URBAN DESIGN COMMITTEE

URBAN DESIGN COMMITTEE STAFF REPORT

APPLICATION NUMBER	Urban Design Record #23110
APPLICATION TYPE	Waiver of Downtown Design Standards
ADDRESS/LOCATION	139 S 10th Street
HEARING DATE	October 03, 2023
ADDITIONAL MEETINGS	-
APPLICANT	Derek Zimmerman and Justin Hernandez, derek@revdev.com
STAFF CONTACT	Arvind Gopalakrishnan, 402-441-6361, agopalakrishnan@lincoln.ne.gov

UDR23110 - Terminal Parking Design (139 S 10th Street)

ATTACHMENT B –Proposed Site Plan with dimensions

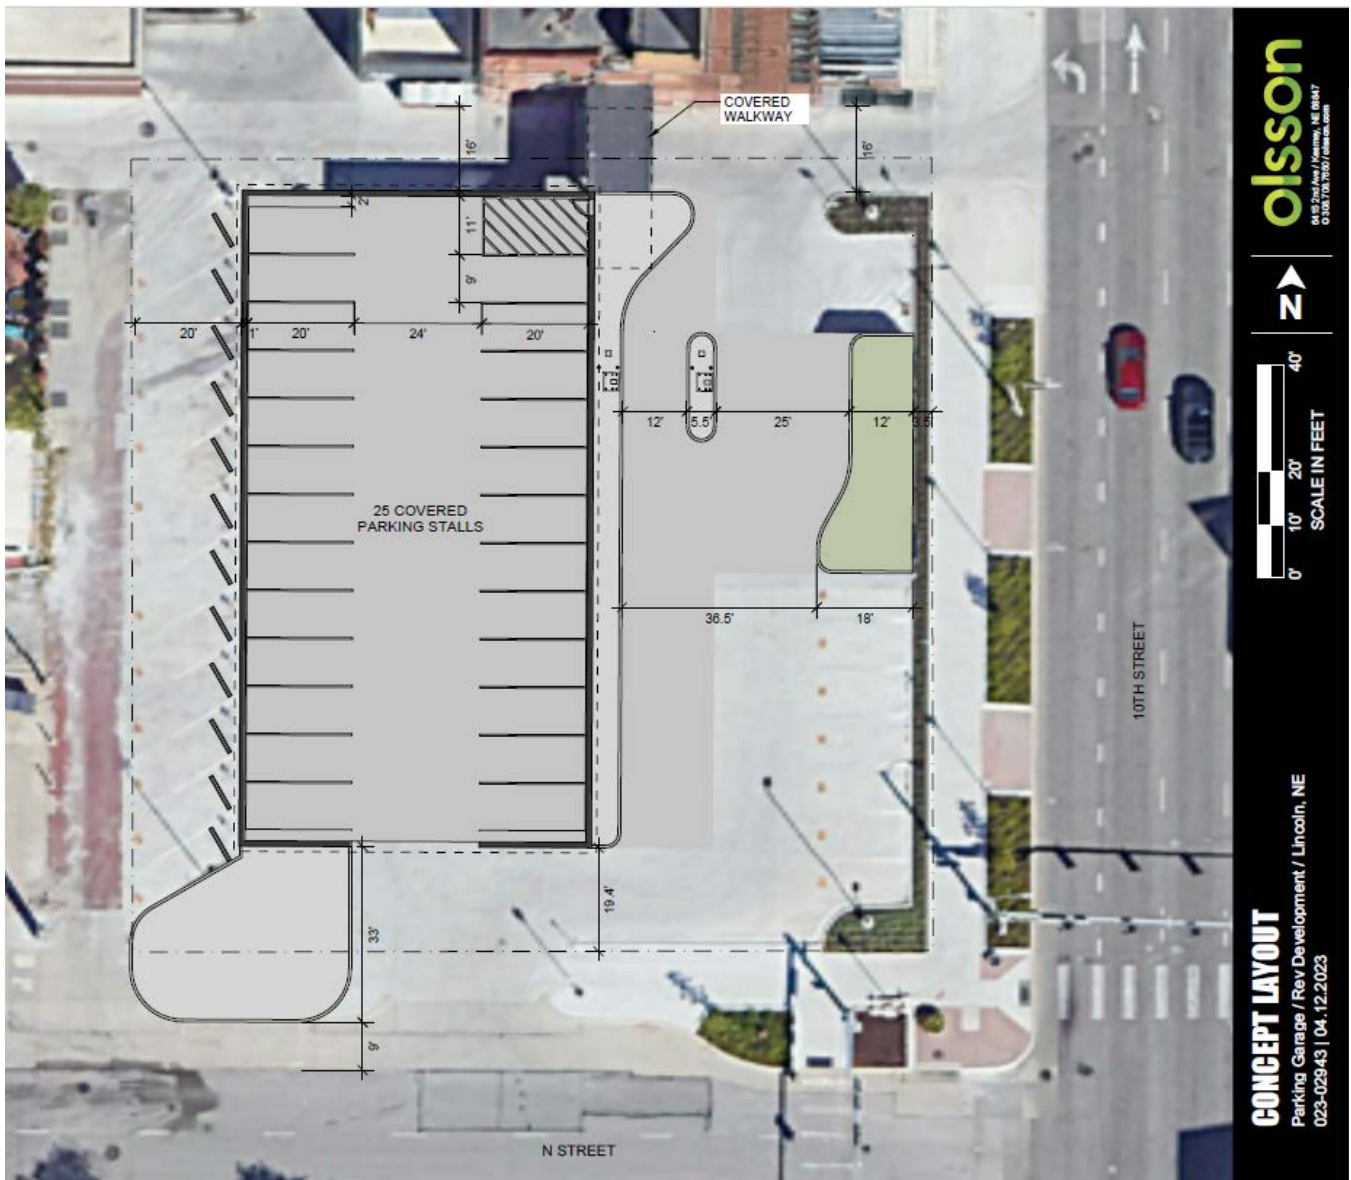
The current proposal shows planting along 10th street and part of N street.

- Parking and driveways between a building and the street are prohibited with two exceptions:
 - o hotels may offer drop-off lanes at their principal entrance; and
 - o buildings situated on a parcel occupying an entire blockface may be built to one corner (fronting two streets) and may offer screened parking behind and/or beside the building.
- Drive-through lanes, if used, must be located behind or beside buildings, and are prohibited between the building and streets. - *Non-compliant, but currently approved by Planning Director waiver.*

- Drive-through facilities (in which the customer is served directly in the car including, but not limited to, drive-in teller windows and ATMs, drive-in restaurants, motorized vehicle fuel sales facilities, motorized vehicle repair/service, or motorized vehicle wash facilities) are prohibited in the area of the B-4 Lincoln Center Business District bounded by 10th Street, 150 feet north of P Street, 14th Street, and N Street. - *Non-compliant, but currently approved by Planning Director waiver.*
